5.2 T220285 PA - Use and Development of Land for a Medical Centre and alteration of an access in a Transport Zone Schedule 2 at 337 Belgrave-Gembrook Road, Emerald

APPLICATION NO.:	T220285
APPLICANT:	XWB Consulting
LAND:	L14 LP14785, 337 Belgrave-Gembrook Road, Emerald VIC 3782
PROPOSAL:	Use and Development of Land for a Medical Centre and alteration of access to a road in a Transport Zone 2.
PLANNING CONTROLS:	Zone:

Client
Mandala Medical Clinic
 Proposed Commercial Development at
No.337 Belgrave Gembrook Road
Emerald, Vic. 3782

Plan:
Basement Level 2 Site/Floor Plan

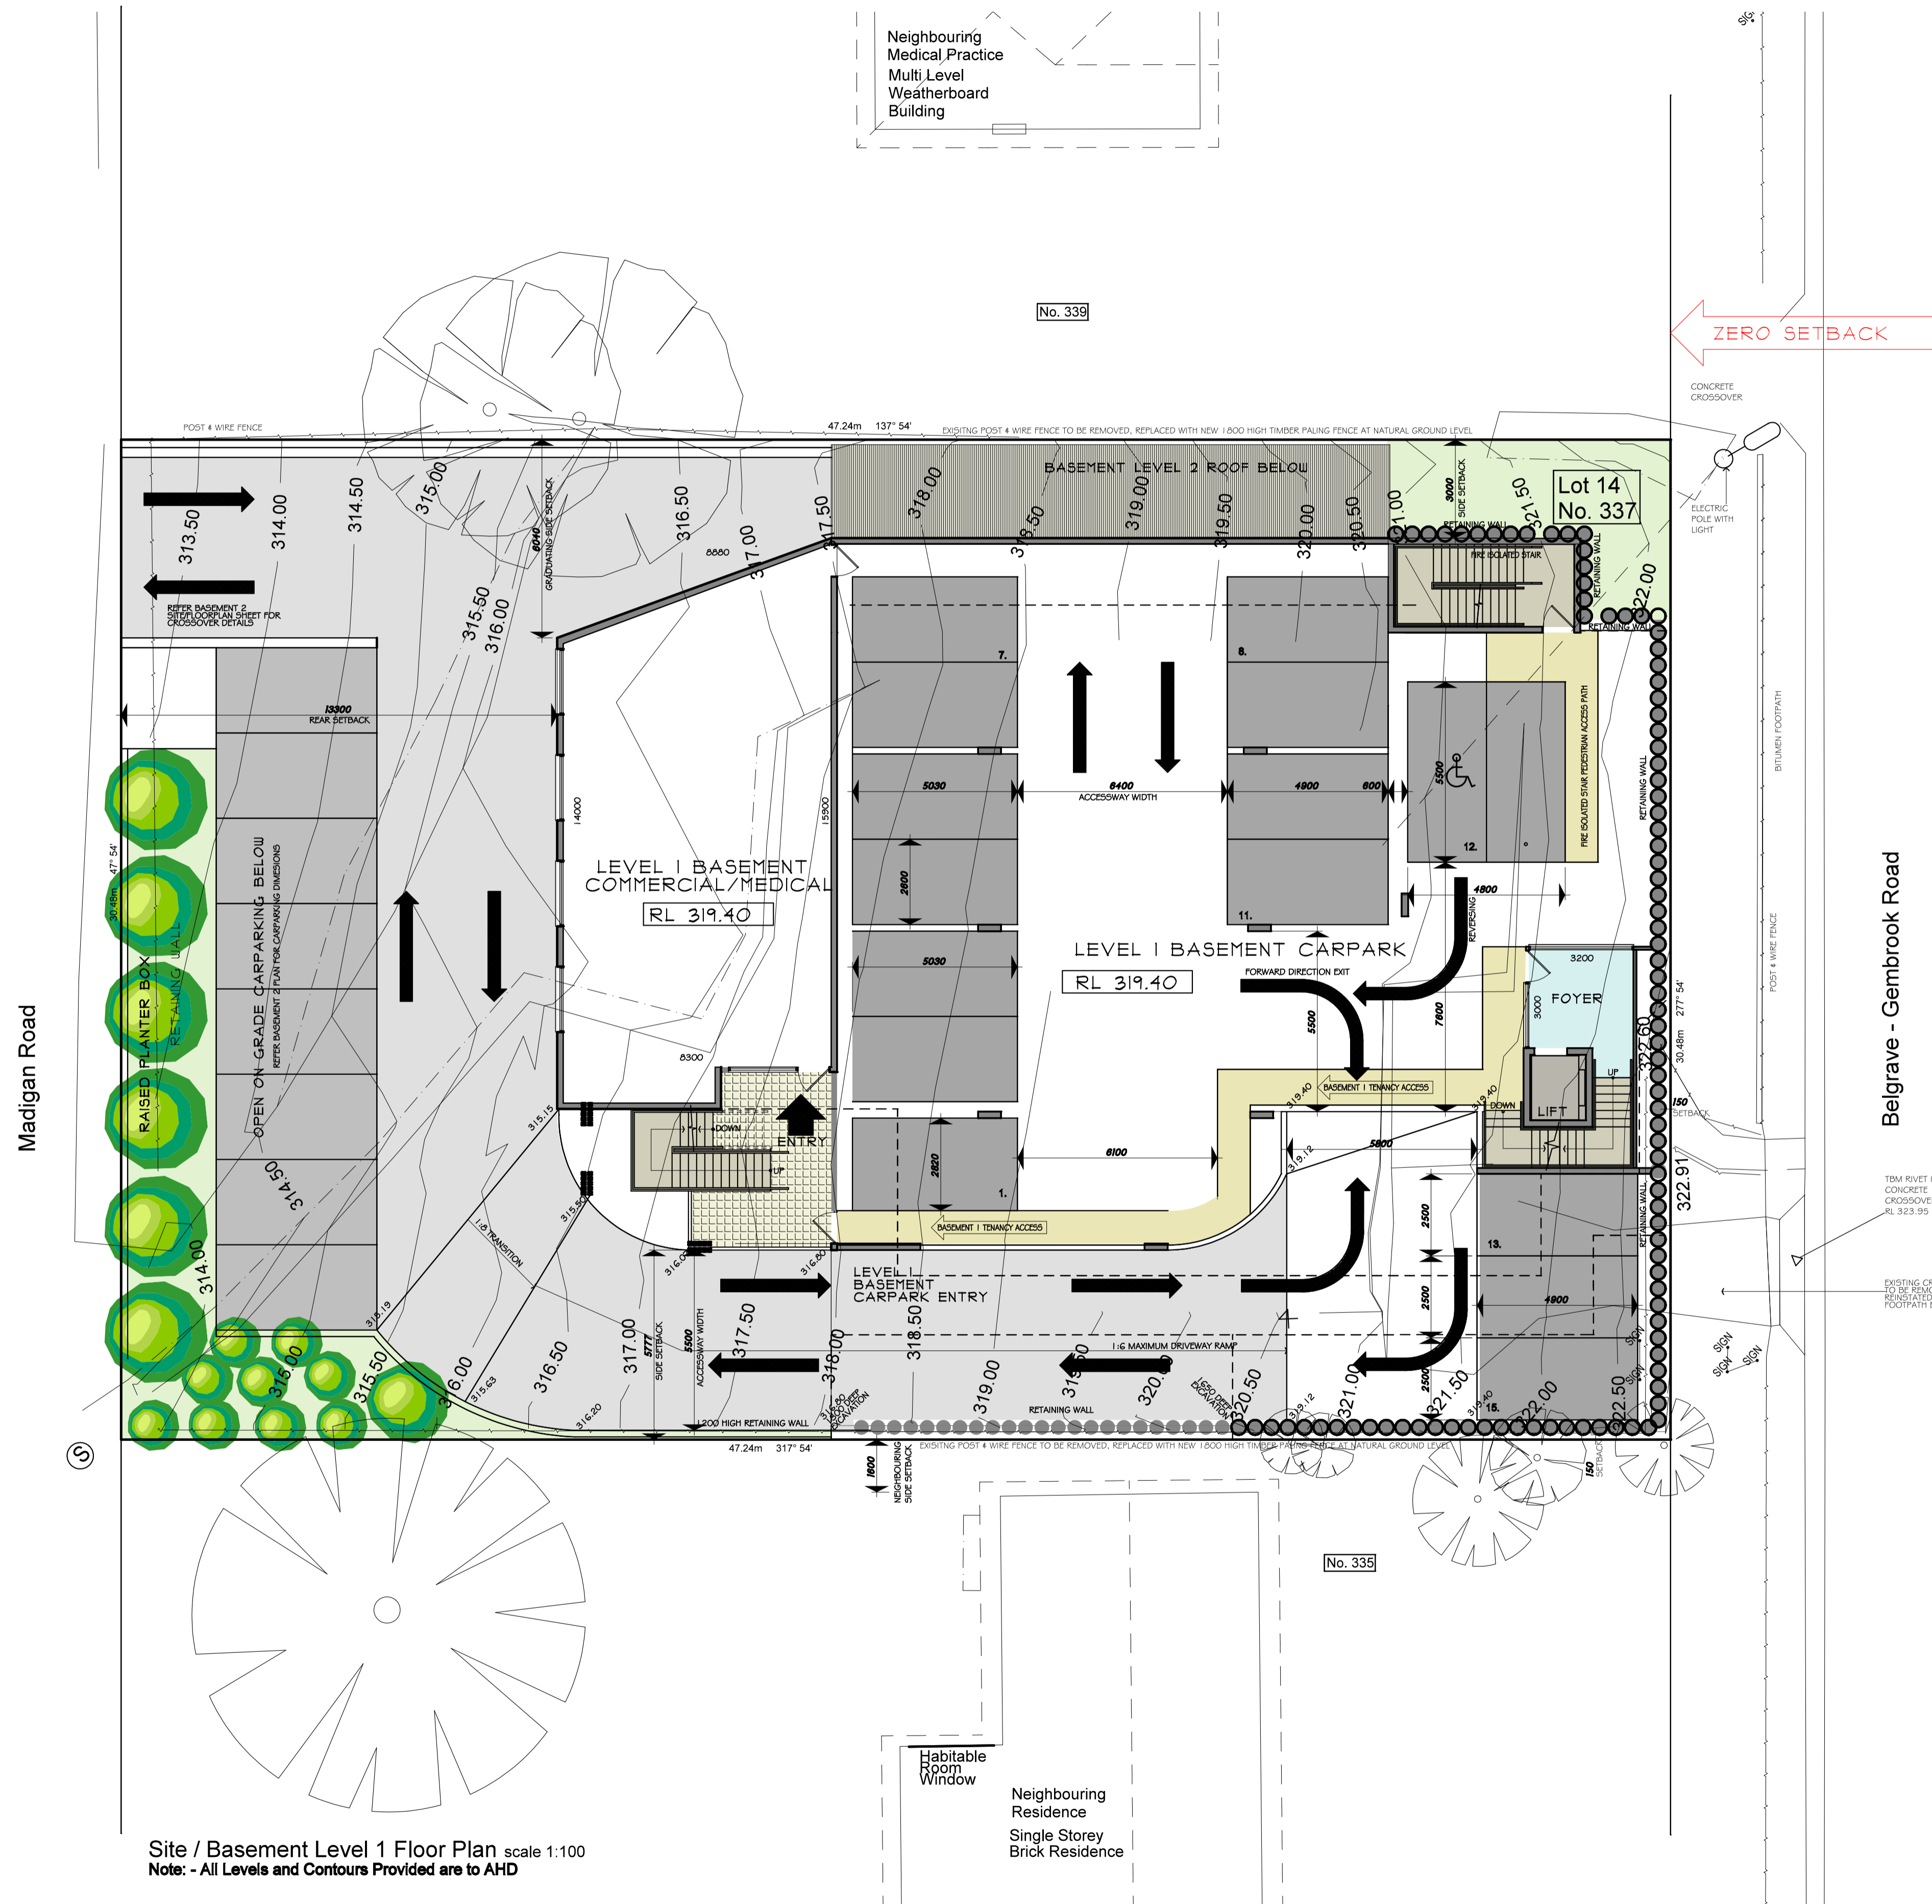
- f. Provision of minimum 500mm overhang for Car Parking Bay 8, Bay 28, Bay 29 ensuring relevant accessway width remains.
 - g. Bay 25 (no clearance to disabled bays) to be removed from level 2 basement carpark, ensuring that minimum 1.2m pedestrian access maintained.

- h. Clarification and update to Bay 24 and a 1m clearance between Bay 24 and Lift, noting this is shown on Swept Path Assessment but not basement floor plan.
